RFB947601-02 ADDENDUM #01

PROJECT: 9476.01 HHS STS New Garage Building – Phase 2

ADDENDUM NO. 1
IDAS HHS STS
NEW GARAGE BUILDING REBID #2
Eldora, Iowa

HGM PROJECT # 106025

project **HHS STS NEW GARAGE BLDG**
3211 Edgington Ave, Eldora, IA 50627
client IOWA DEPARTMENT OF ADMINISTRATIVE SERVICES
sheet **FOUNDATION PLAN & DETAILS**

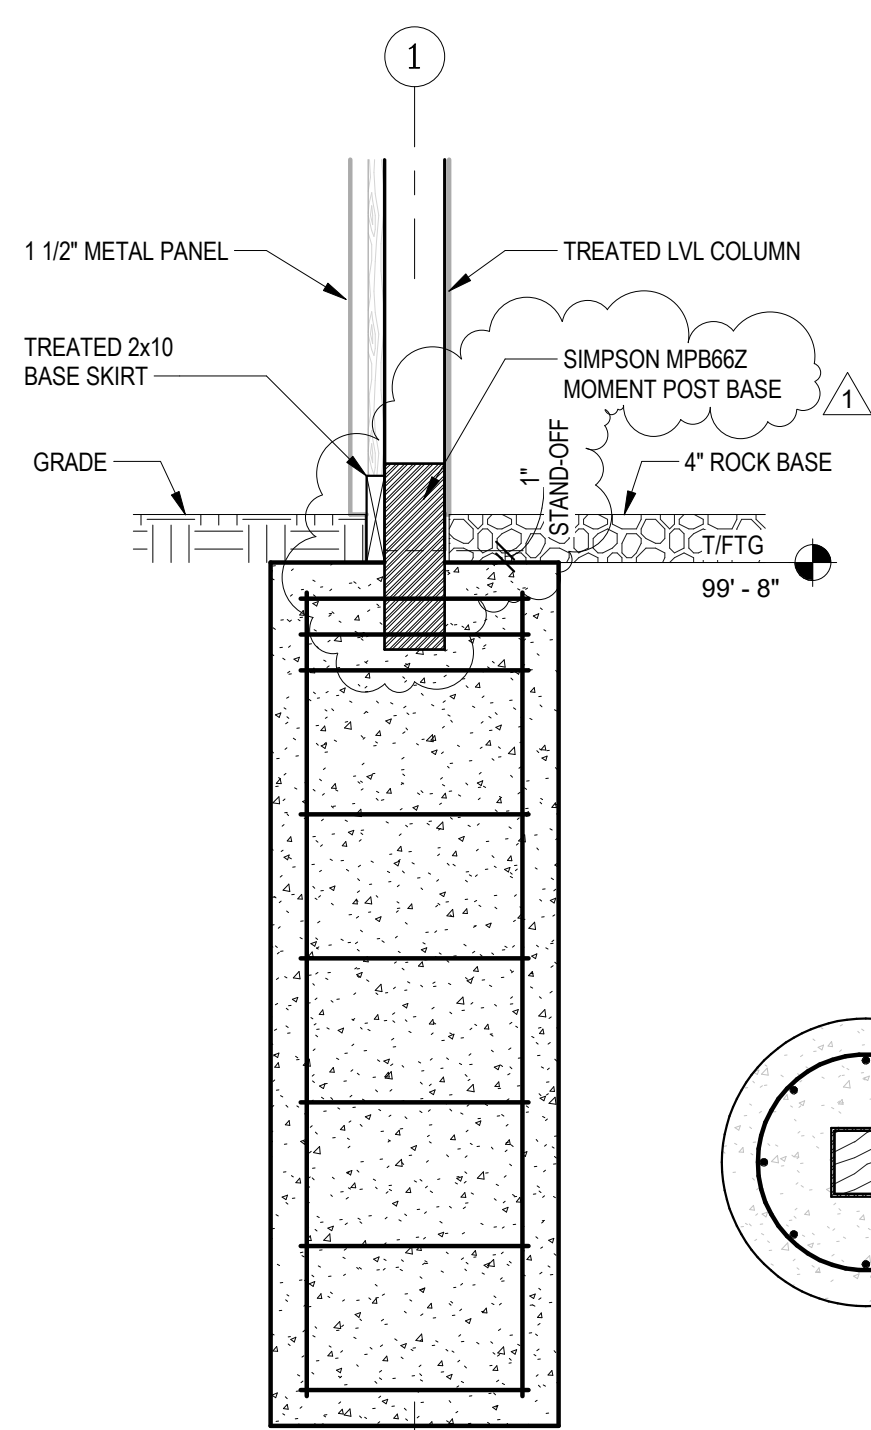
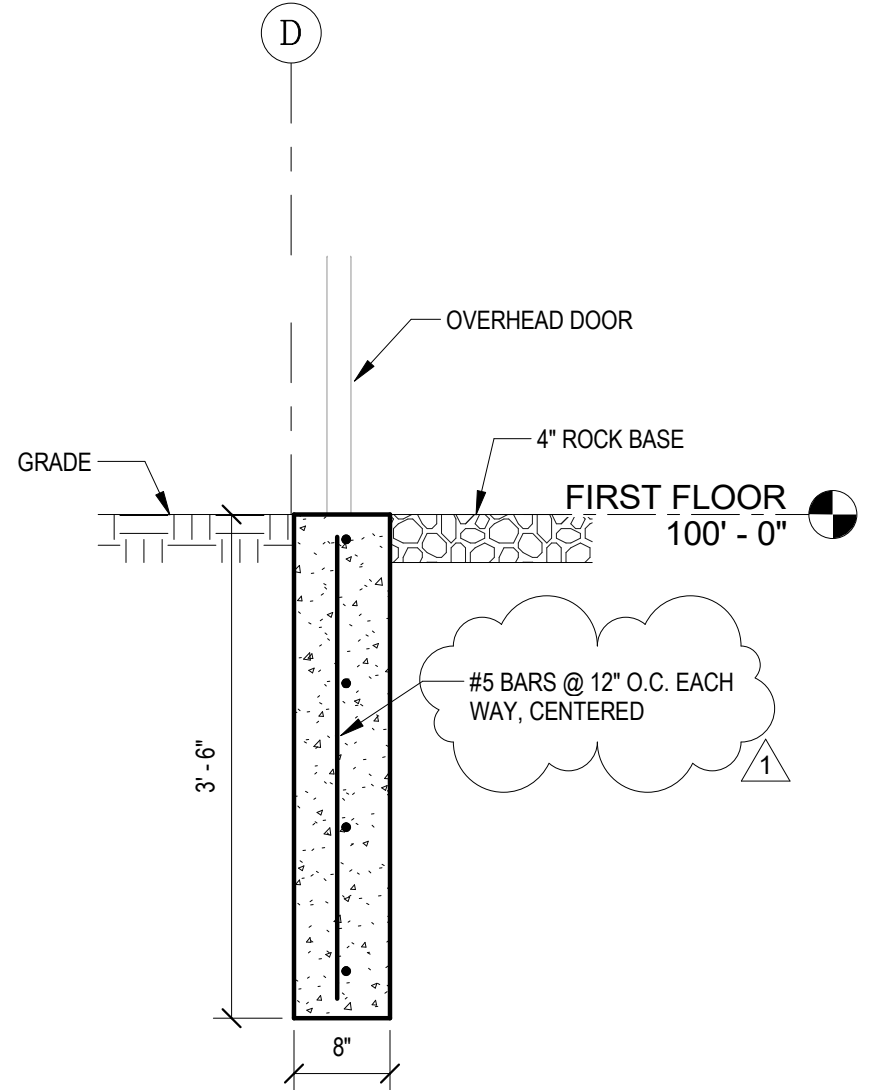
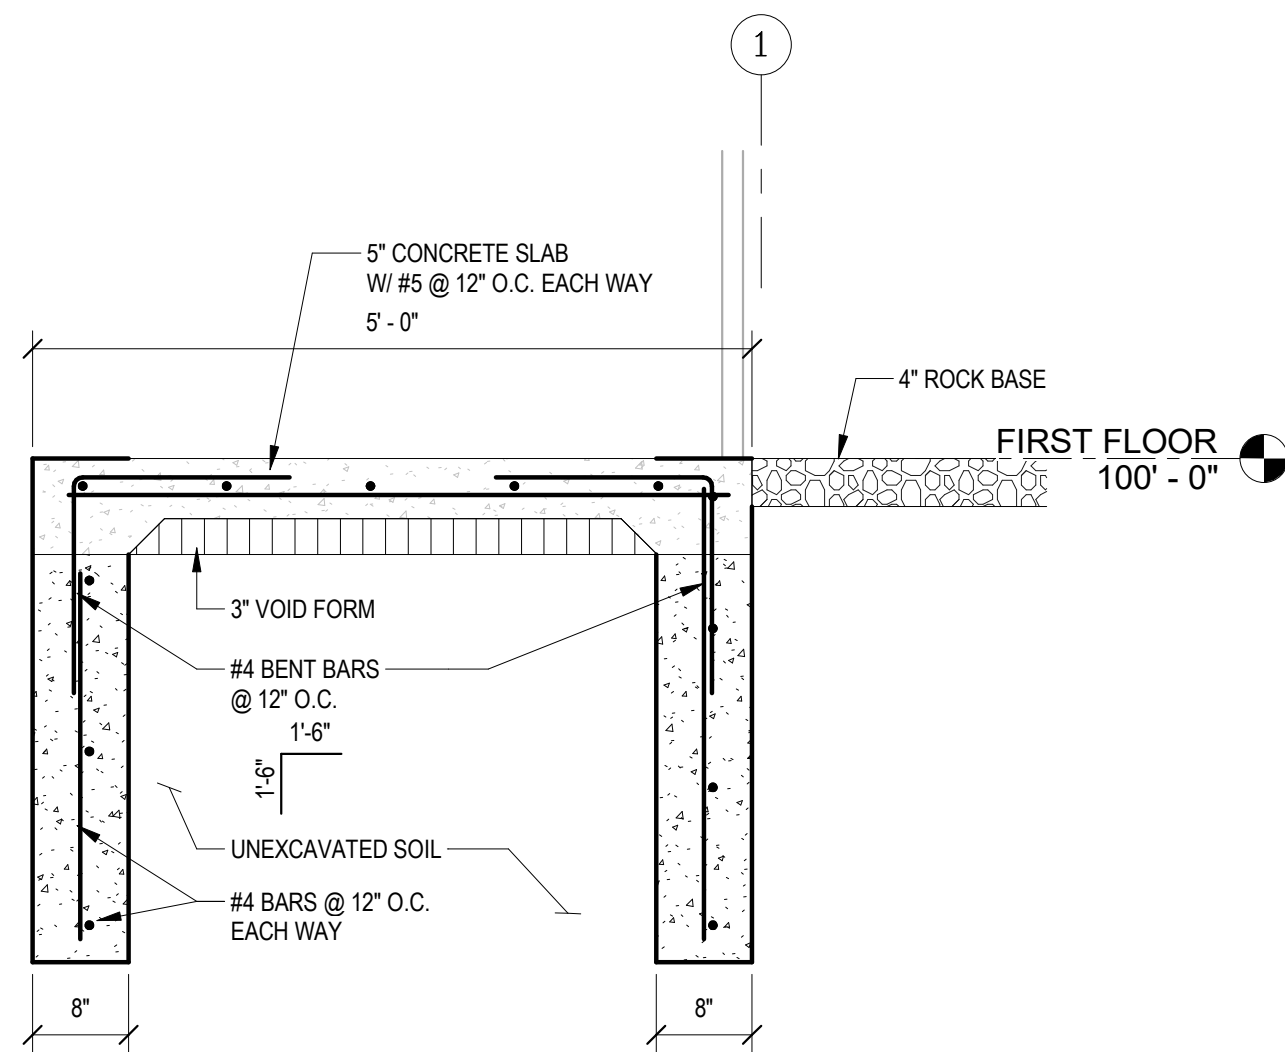
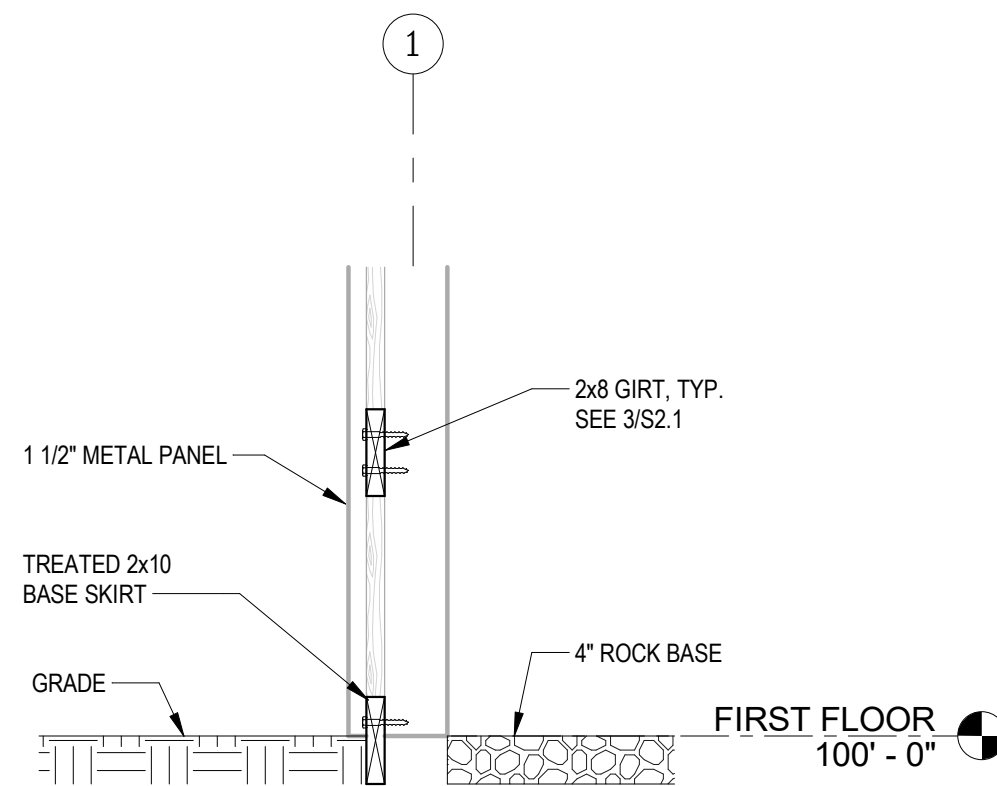
- Q8: Are the grade beams under the garage door thresholds connected to the post foundations? Also are the grade beams 8 inch thick?
- A: Yes, the grade beams are 8" wide. They do not need to connect to the column footings.

- A: Fixture series should be CBRB. The Prime Contractor to coordinate with sub-contractors for responsibility and scope.
- Q20: It appears that the treated lvl posts are not supposed to be buried, they are also not supposed to be wrapped in a waterproof membrane. What is the solution for this dilemma?

- A: Use Simpson MPB66Z Moment Post Base in lieu of embedding column.
- Q21: Another dilemma with the posts is the load rating. The posts are designed for 7,700 pounds if placed in a way that the post direct loads to a footing. The way the posts are designed shows the post being supported entirely from friction against the concrete and no direct loading. This could cause the building if ever fully loaded to shove the post into the ground and cause part of the building to fail. Another thing is the beams running the perimeter of the building are undersized to meet the loading specs of that area the beams would have to be triple 11 7/8 lvl at minimum. What is the solution for this issue?

sheet **ROOF FRAMING PLAN & DETAILS**

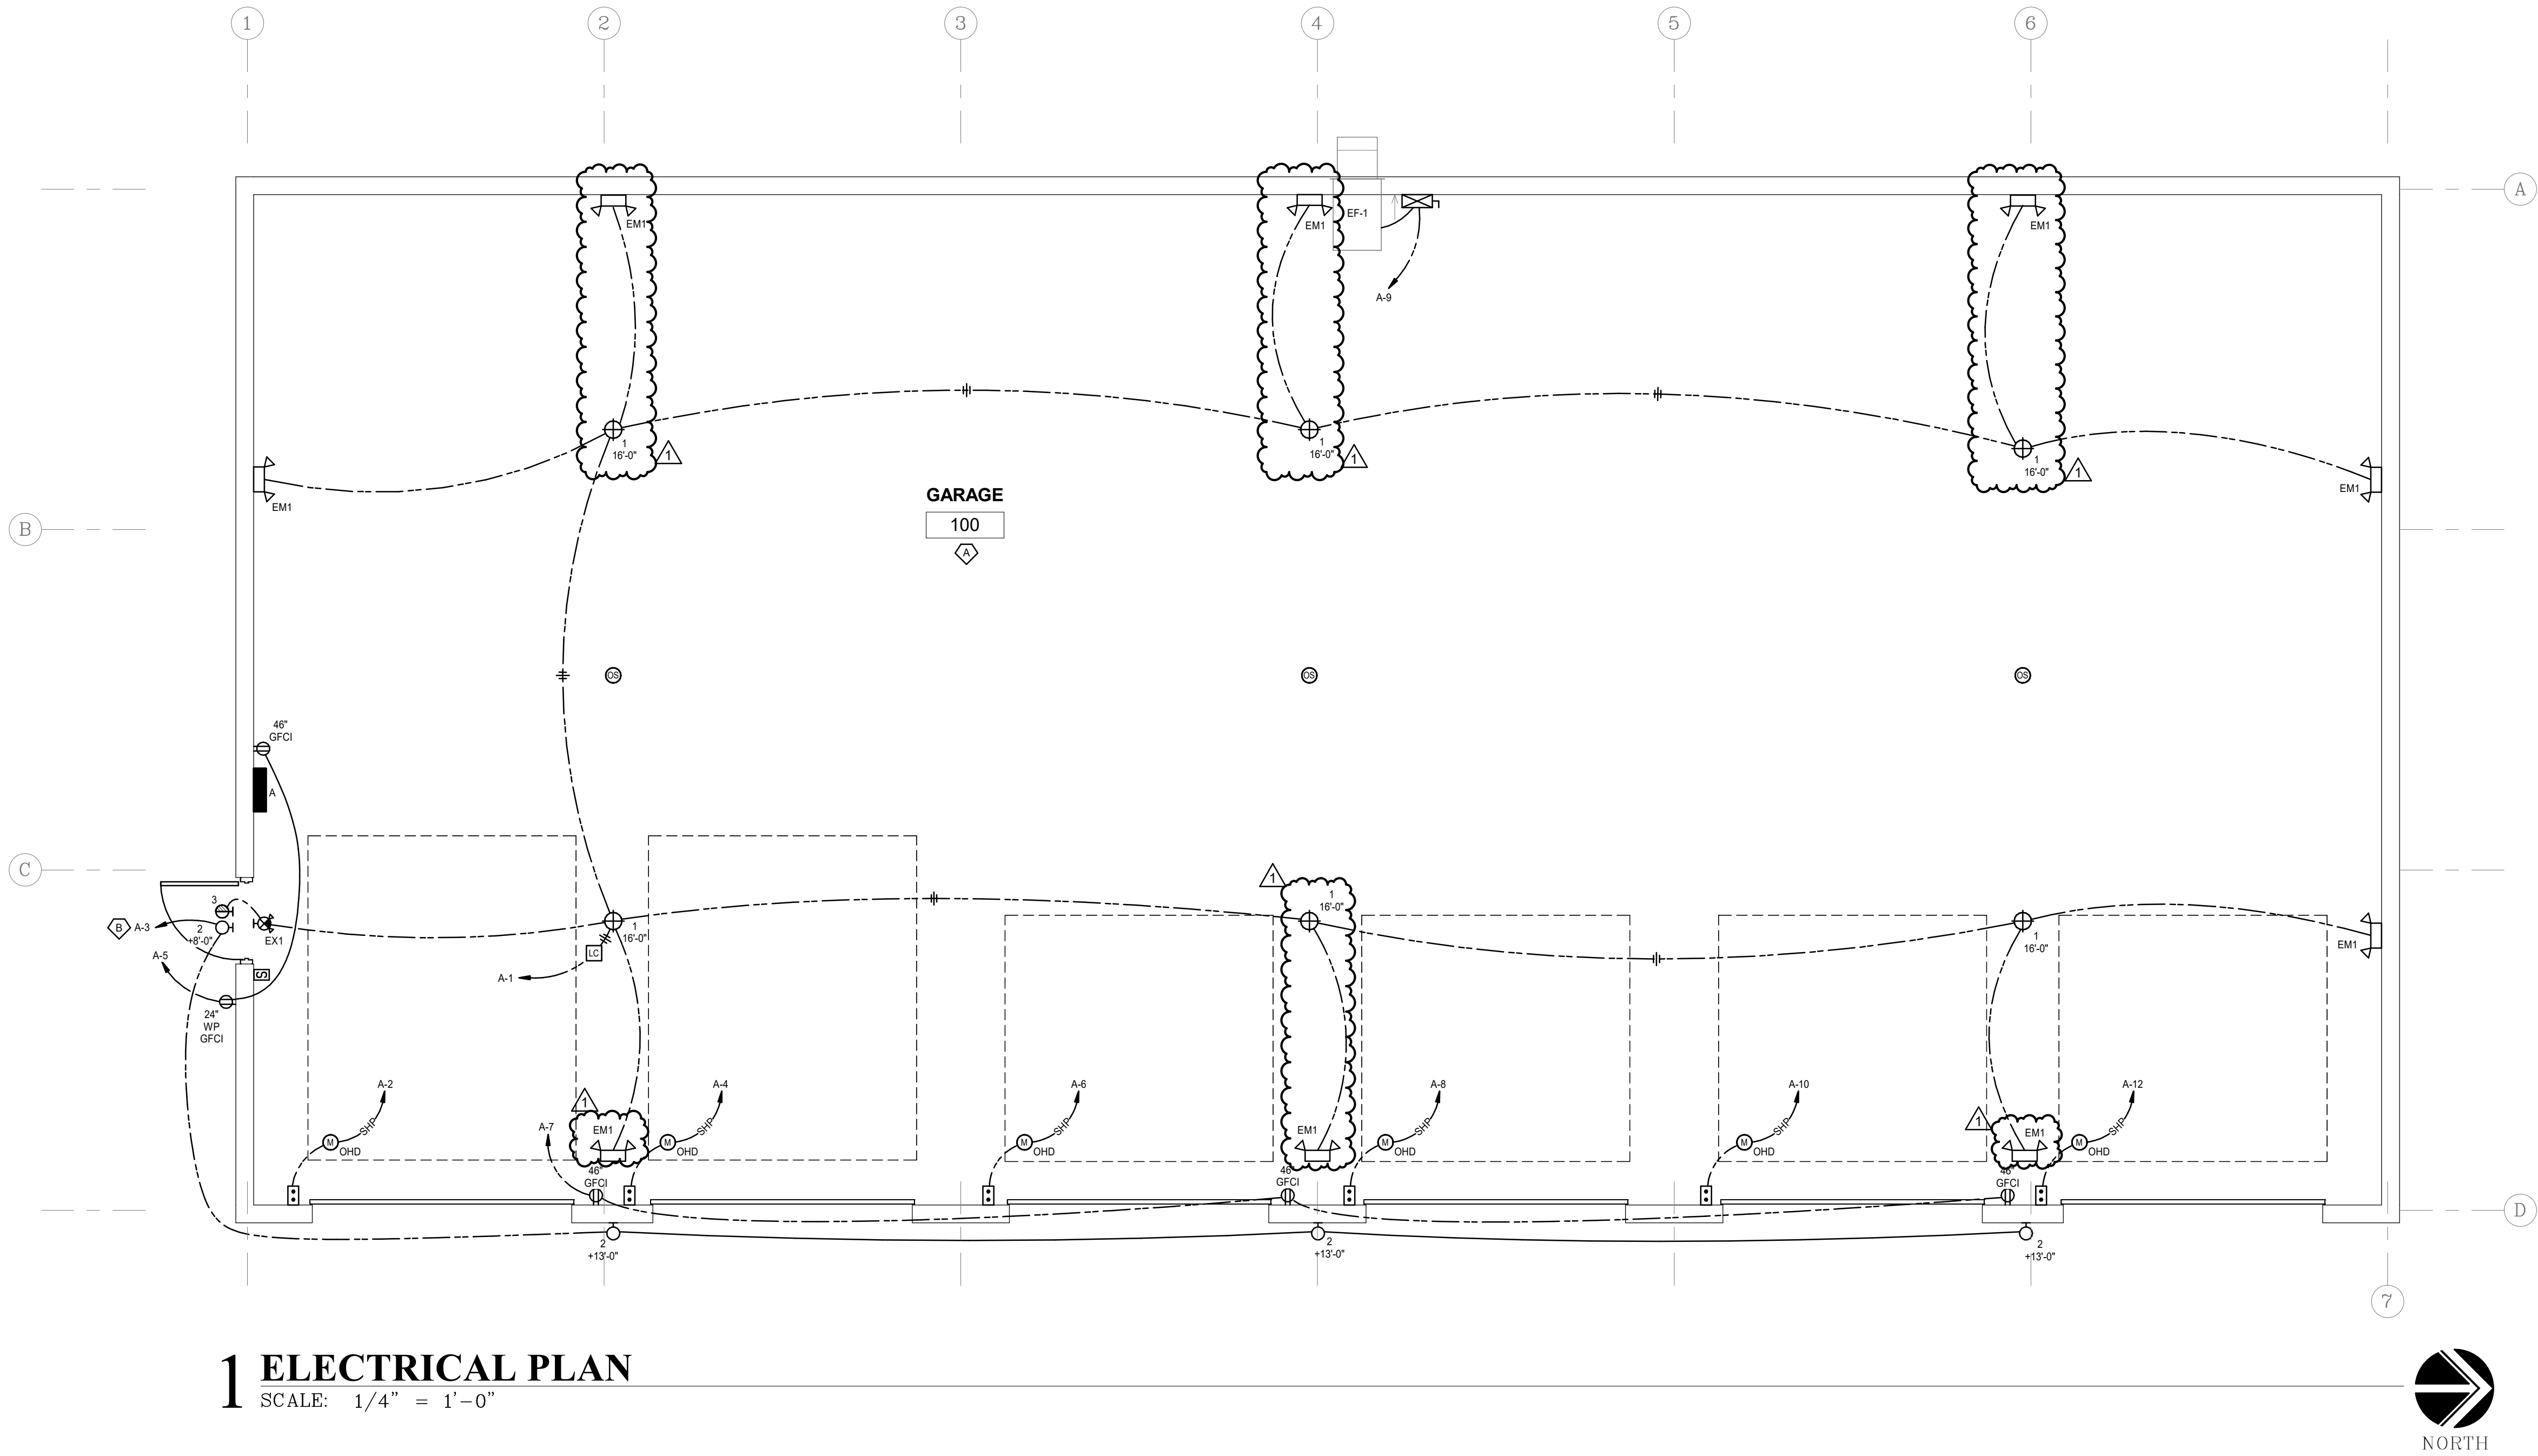
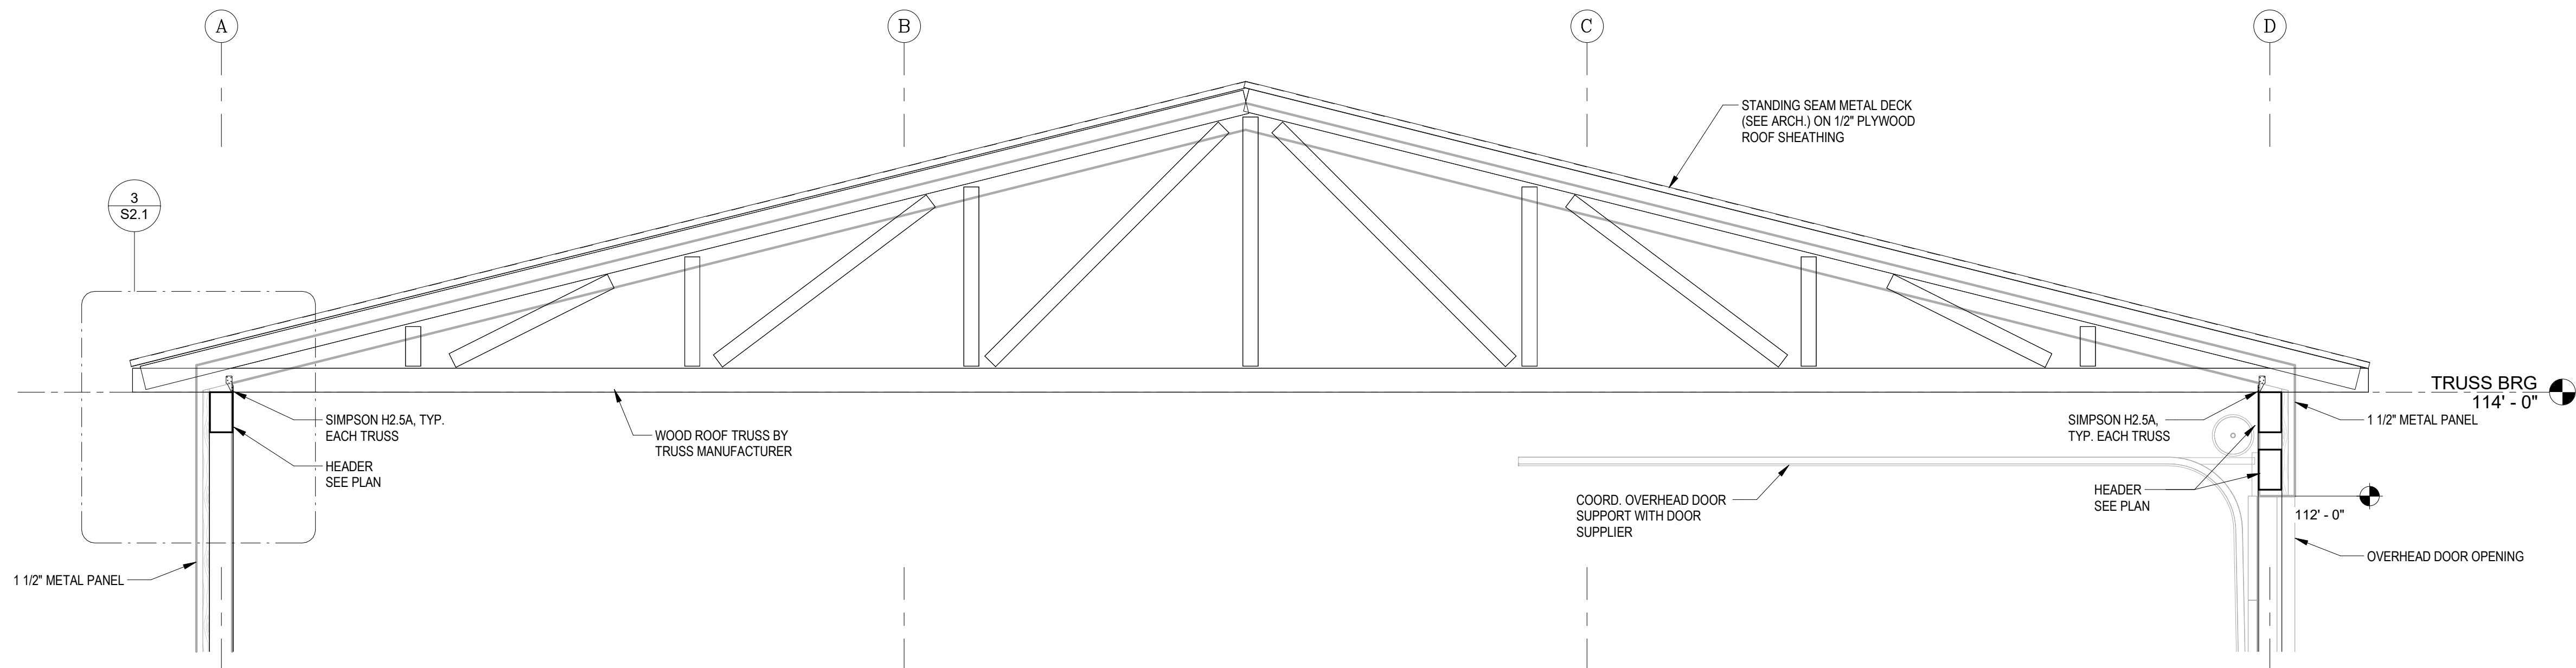
- Q10: Also, 1/2 osb cannot span 4ft, what was the plan here? Also, are we attaching the steel to the osb? If so most manufacturer warranties would be voided by this installation a minimum 5/8 CDX or osb is required.

B. SHEET S2.1 – ROOF FRAMING PLAN & DETAILS

- A: OSB to span 2ft. See attached S2.1 Sheet. Metal roof panels and OSB shall be fastened to the roof trusses.
- Q11: Is there a specific grade of fill soil that you want us to use? Also is there a specific type of rock that you want us to use for the floor?
